# Net Zero Teesside Project

Document Reference: 9.27 Applicants' Response to the Examining Authority's Second Written Questions

Date: August 2022

Project: NZT DCO Land Plans (D6)  
Net Zero and Anglo American (AA) Key Interface Areas

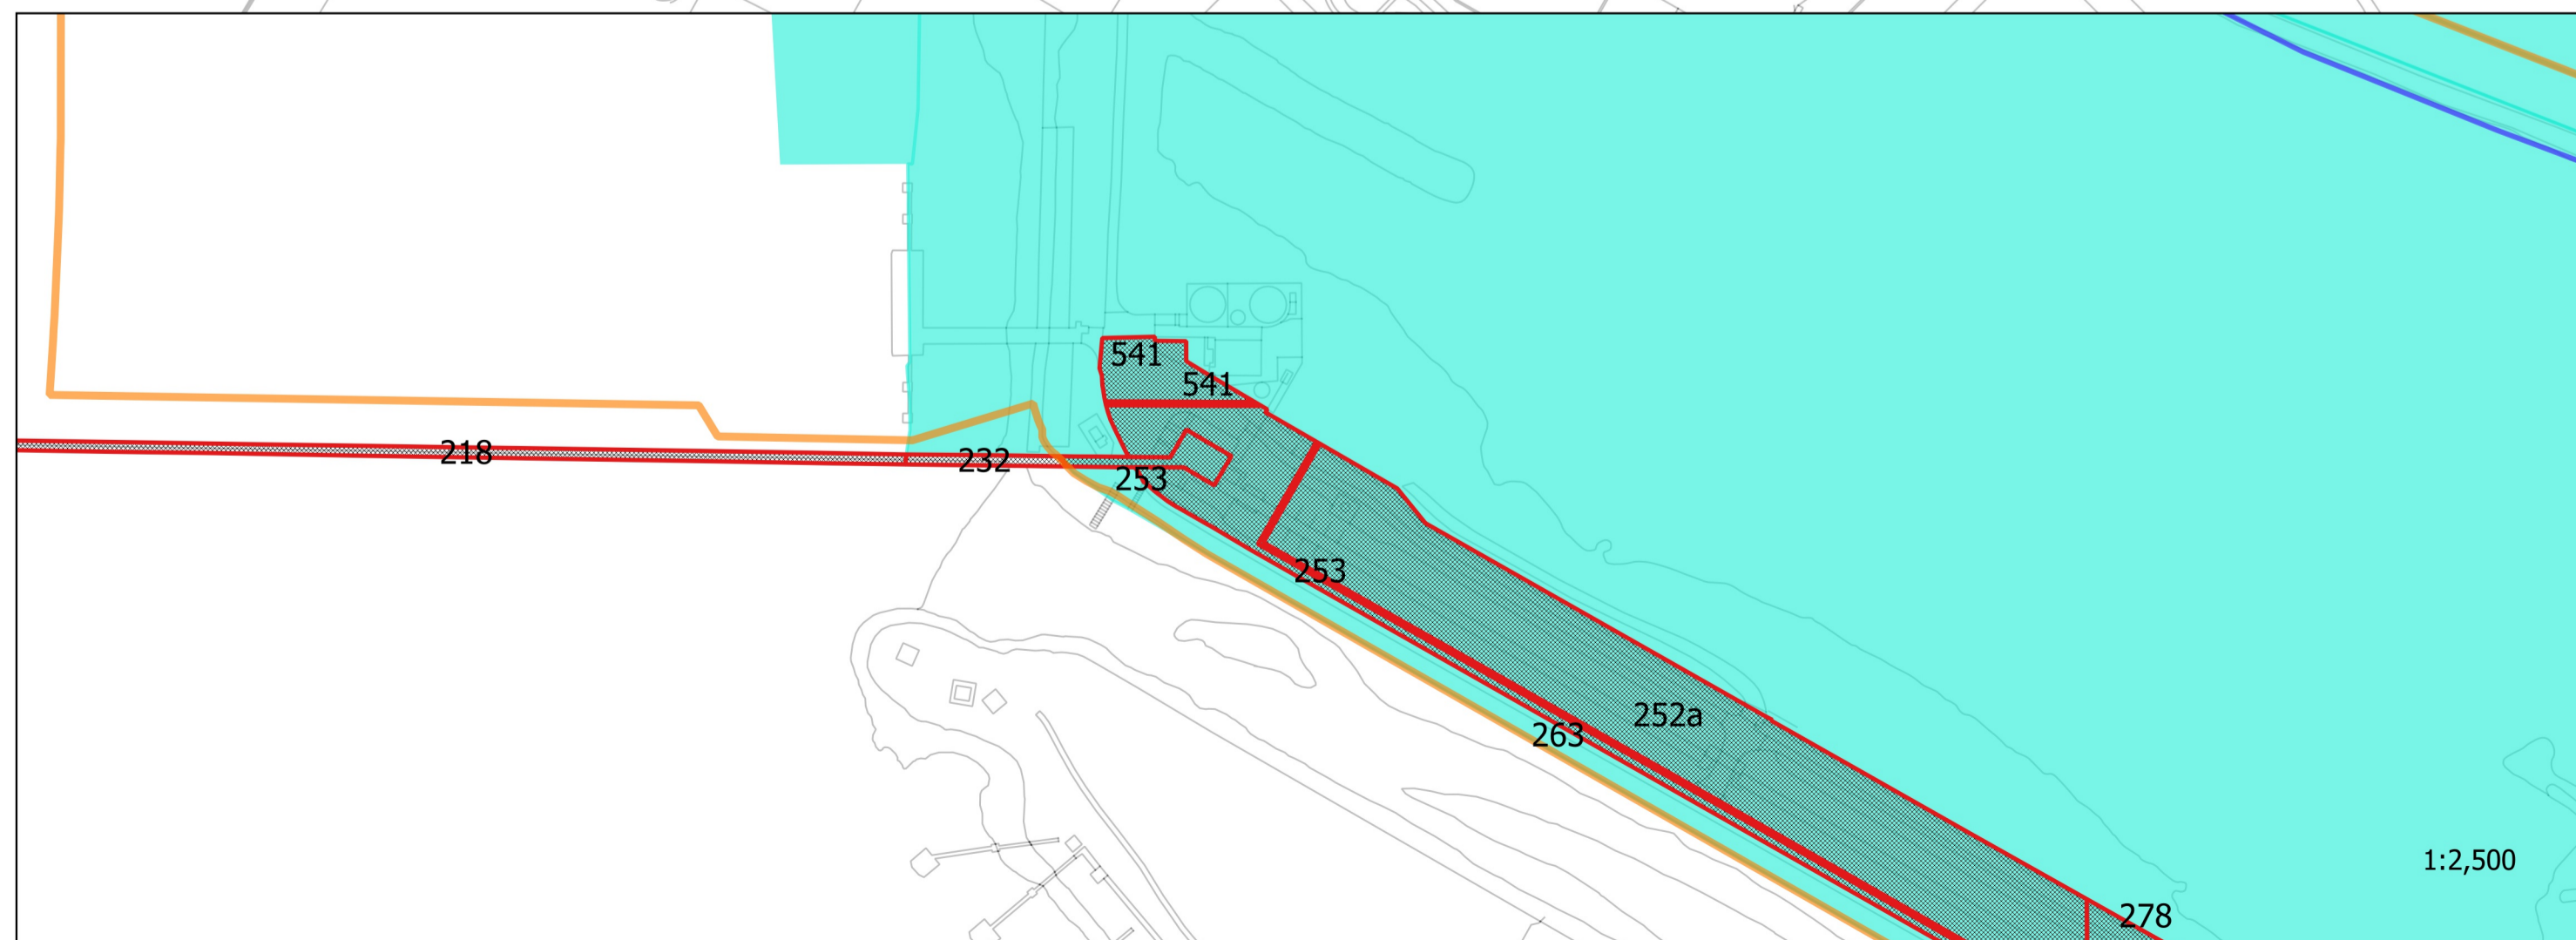
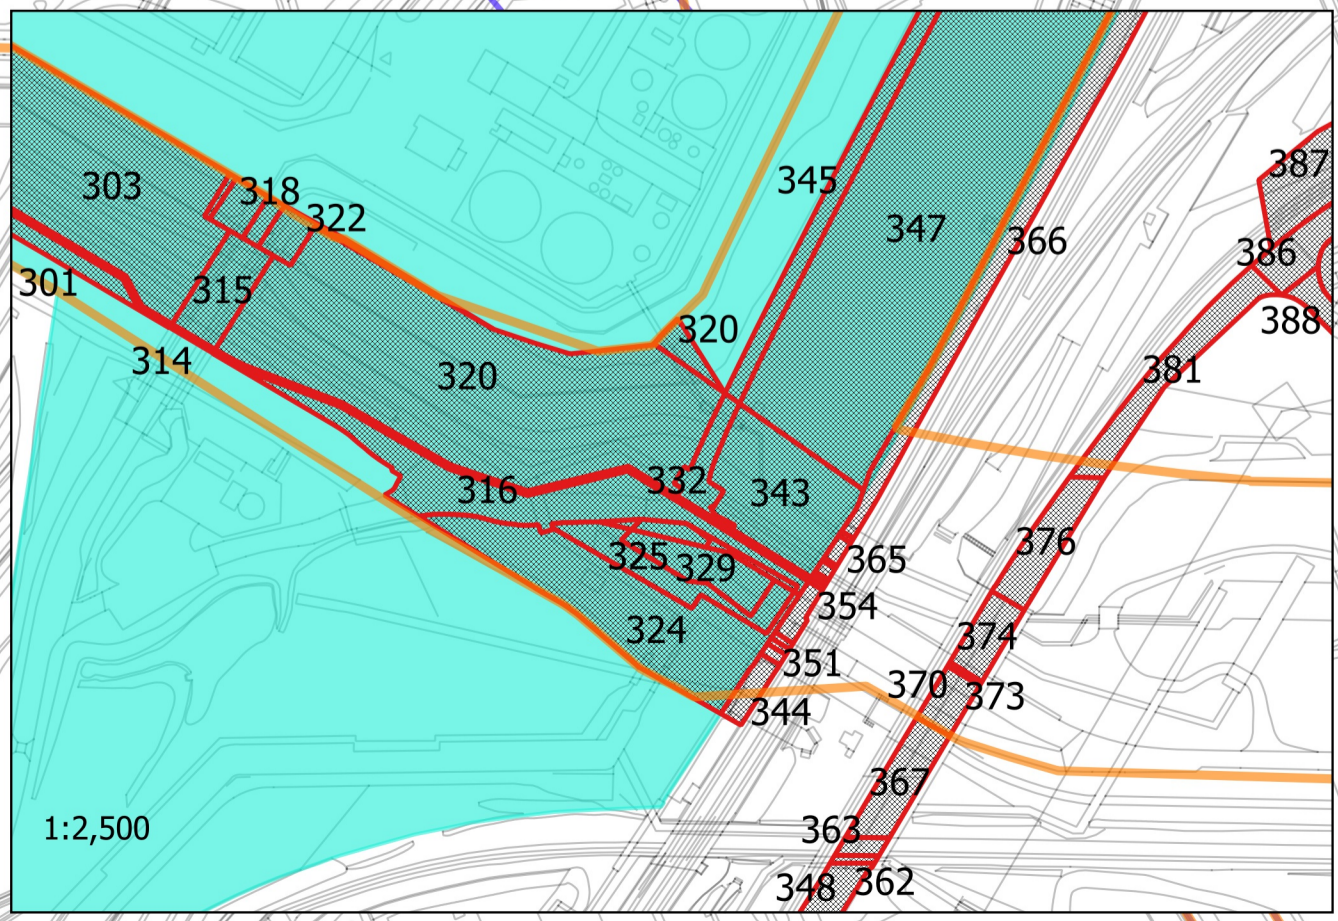
GEN.2.3	Anglo American Applicants	<p>The SoCG between the Applicants and Anglo American plc [REP1-030] includes a plan at Appendix A1 providing a comparison of Net Zero Teesside (NZT) DCO Order Limits and Anglo American Overlapping interests. In their response to ExQ1 GEN.1.39 [REP2-073], Anglo American provided some details regarding the current stage of construction of the Woodsmith Project and the Non-Material Change application to the York Potash Harbour Facilities Order 2016.</p> <ul style="list-style-type: none"> <li>i) Can Anglo American provide any updates to these matters, including an anticipated construction start date for the harbour.</li> <li>ii) Are the Applicants aware of any implications for the current programme of construction of Proposed Development?</li> <li>iii) In respect of Appendix A1, due to its size the key is difficult to read and therefore the Applicants are asked to reproduce the key separate from the plan.</li> </ul>	<ul style="list-style-type: none"> <li>ii) The Applicants remain in discussion with Anglo American and continue to collaborate to ensure that both developments can be constructed and co-exist. At this time, the Applicants are not aware of any implications the Anglo American development would have on the programme for the Proposed Development.</li> <li>iii) The Applicants have submitted a revised plan of overlapping interests for the Proposed Development and Anglo American. The plan reflects the revised Order Limits submitted as part of the change request at Deadline 6. This is included at Appendix GEN.2.3.</li> </ul>
